Consultation Objection from 4 Parkhill Road

We have read the report from structural engineers Webb Yates on the proposed demolition and excavation at 4b Parkhill Road and have discussed it with architects and structural engineers. We have two objections arising from this additional submission:

Ties inserted at first and second floor level

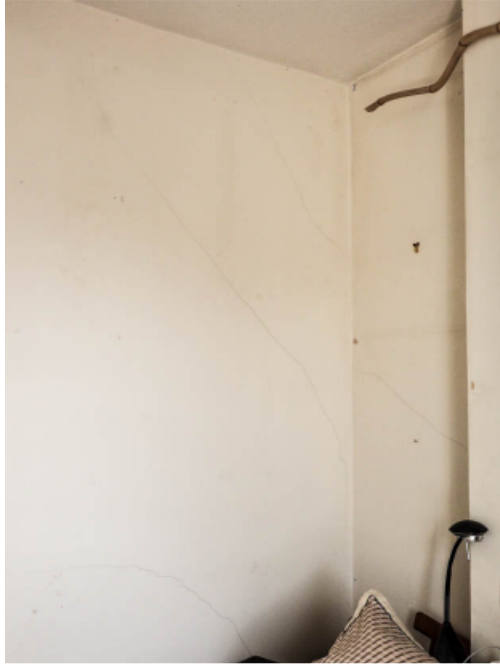
When we moved into 4 Parkhill Road in 2000 there was significant evidence of structural distress and movement in our property: our top staircase, attached to the party wall with 4b, has a significant lean, and we needed to insert building ties at both first and second floor level to strengthen the party wall at that level.

We subsequently carried out further internal strengthening because of concerns about building movement. All of this work was performed on the basis that the existing building at 4b was providing support to that side of our house. We are very concerned that if the building is demolished and a substantial excavation is carried out below a wall that we know is old and prone to movement that there is a real risk of building collapse.
